Project: New Joplin Library
Site Civil/Landscape Construction Documents
Volume 2 of 2

Client: City of Joplin

ADDENDUM NO. 2

UPDATED DRAWINGS – ADDENDUM #2 LANDSCAPE

SITE PLANTING PLAN

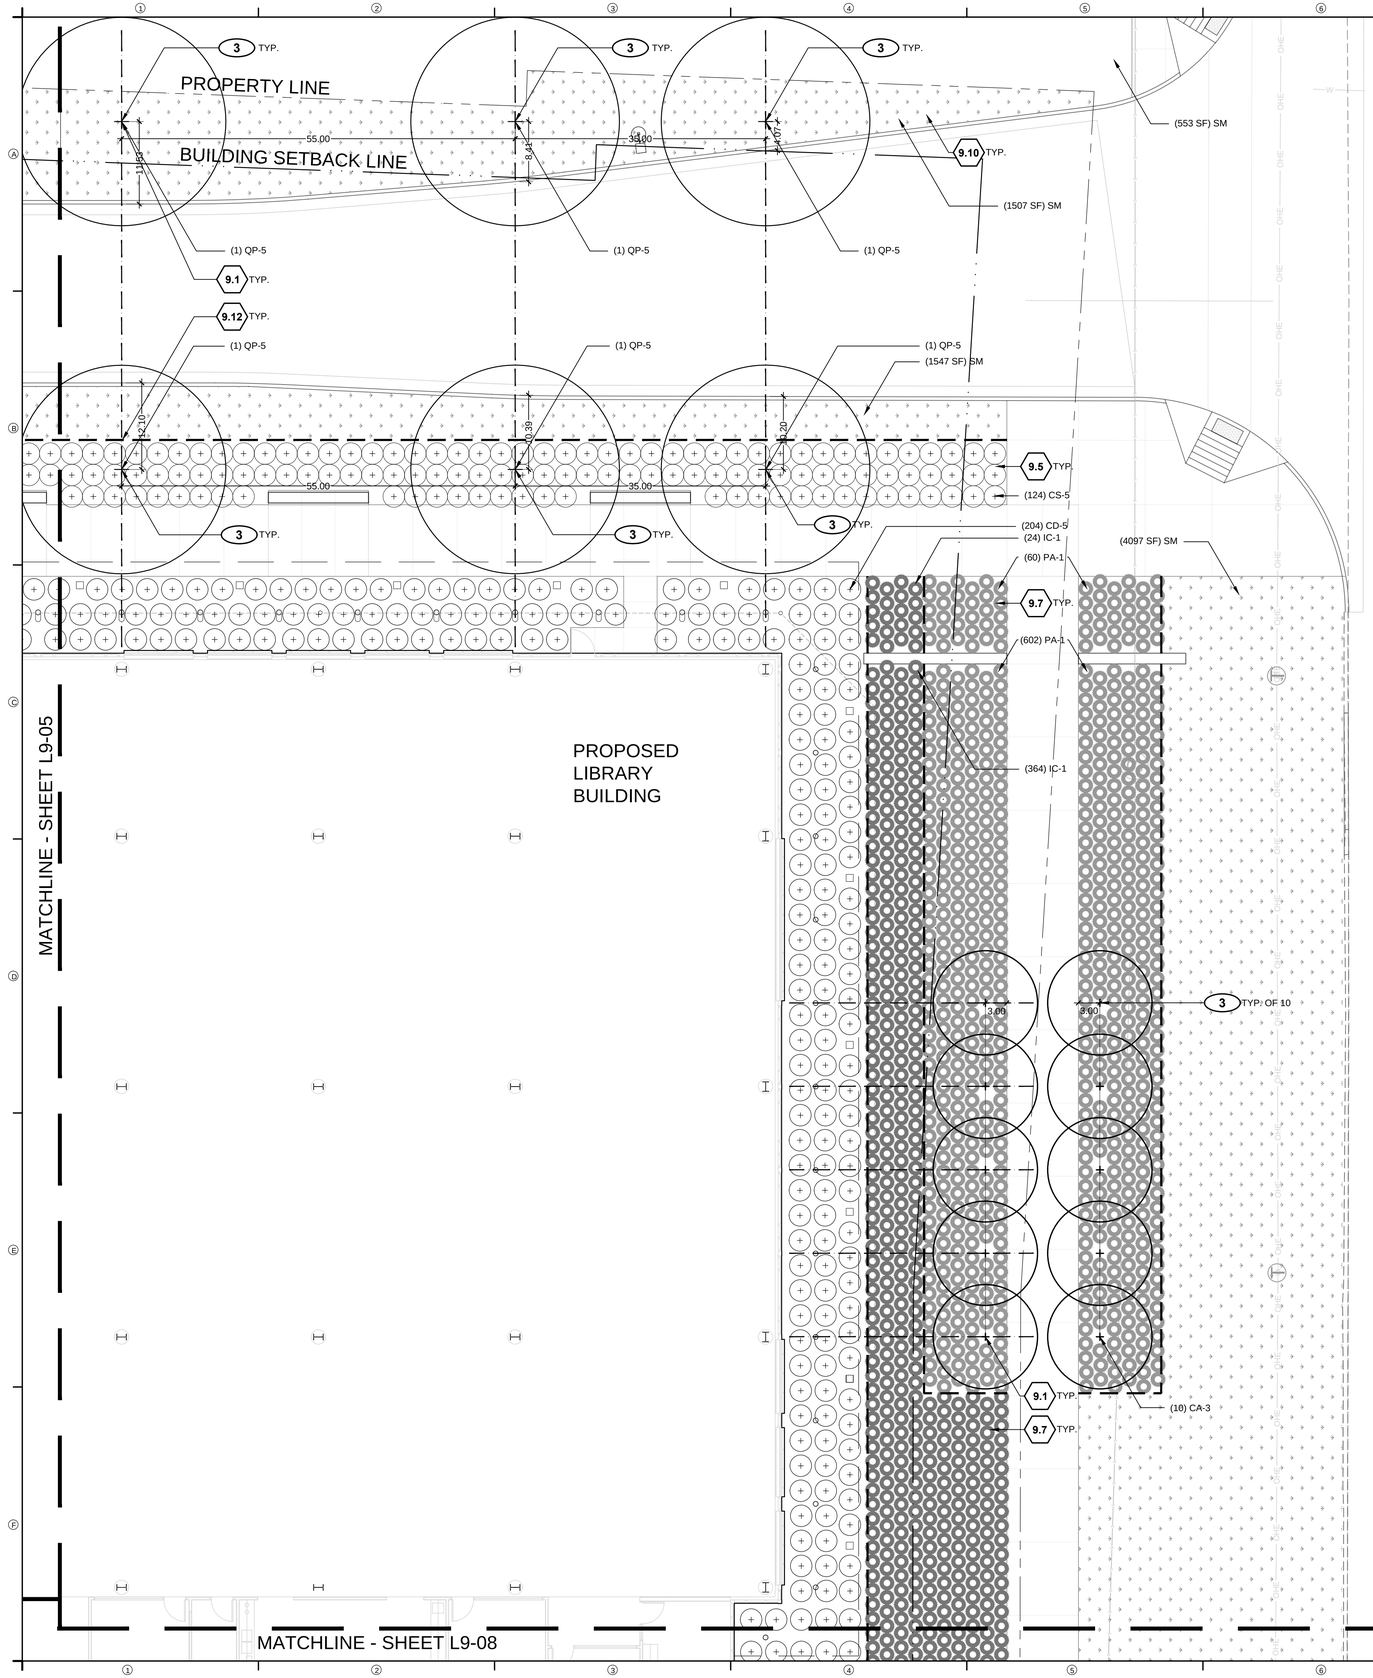
a. plan notes a shrub IV-5, legend notes a IV-3 is that the correct type?

b. plan notes 702SF of PA-B bulbs should that be each and not square feet? Where shown on Sheet 9-08 it does not call out SF.

Sheet L9-06: The Legend has been updated for all sheets to reflect the change from shrub IV-3 to IV-5. Plan has been updated from 702SF of PA-B to 140EA PA-B.

Yes this is correct. Legend has been updated on all sheets to reflect corrections.

This should be 140EA on this sheet. See Quantity totals have not changed on L0-04 as 650 Bulbs total required across site. Drawings reflect updates.

SITE PLANTING PLAN

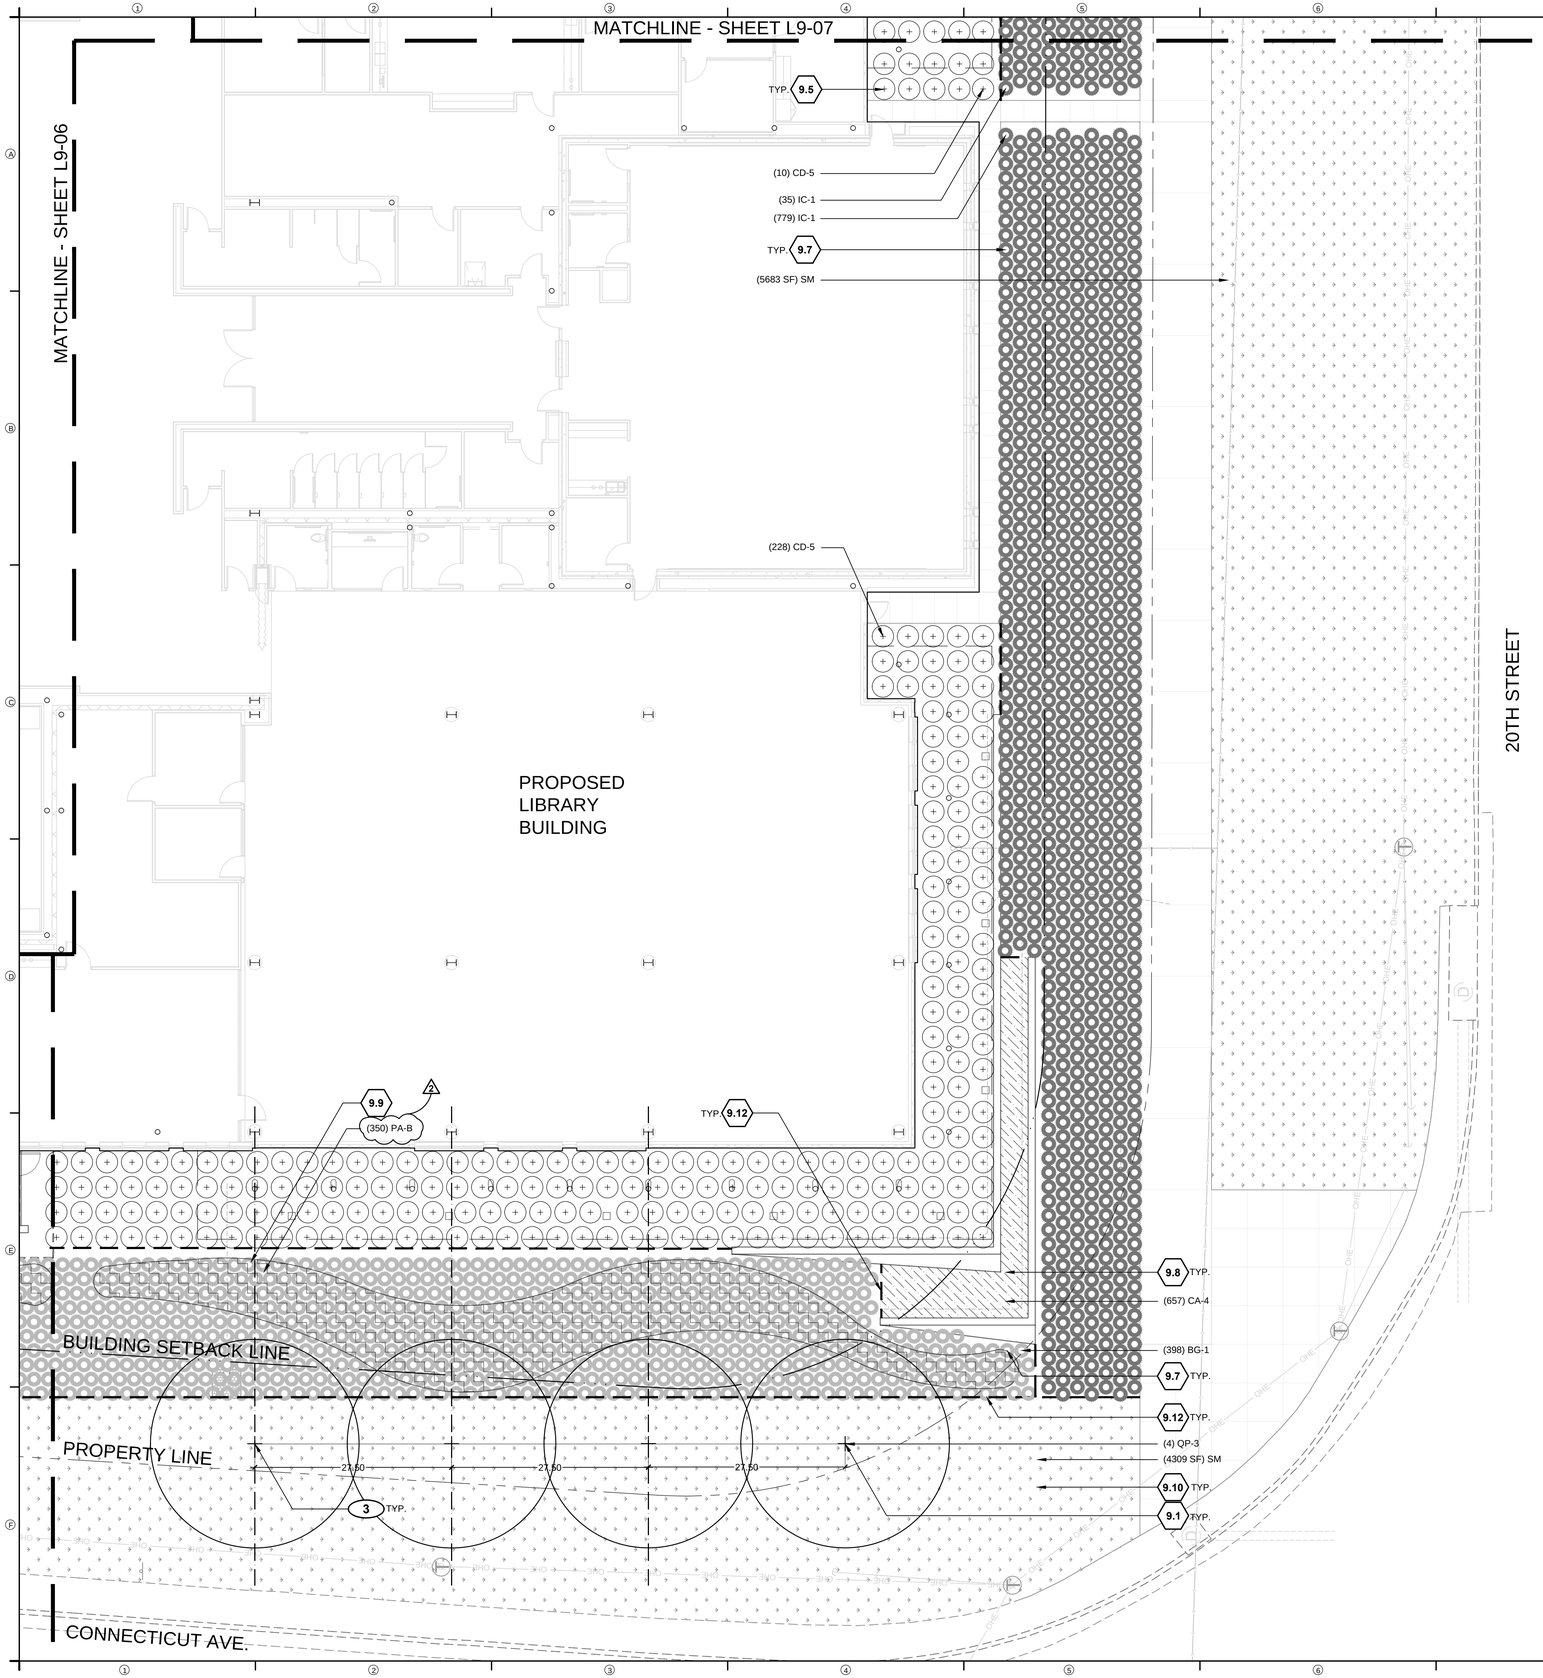
a.plan notes tree QP-5, legend notes a QP-3 is that the correct type?

b. plan notes a CD-5 , legend notes a CD-3 and a CS-5 which is correct? Also there is no notation on plant type directly on east side of building, from sheet 9-05 match line those are called out to be CD-05 is that correct? and again which plant type?

c plan notes plant PA-1, legend notes a PA-1 under both Ornamental grass and Perennials. Which PA-1 is the be used on this sheet?

Sheet L9-07: The Legend has been updated for all sheets to reflect the change from tree type QP-3 to QP-5 as well as changing shrub CD-3 to CD-5.

Yes this is correct. Legend has been updated on all sheets to reflect corrections.

Legend was incorrect. Should be CD-5 as on plan. Legend has been updated to reflect corrections.

This is the Ornamental Grass on this sheet. The Legend has been updated for all sheets to reflect the perennial PA-1 to now be PAF-1.
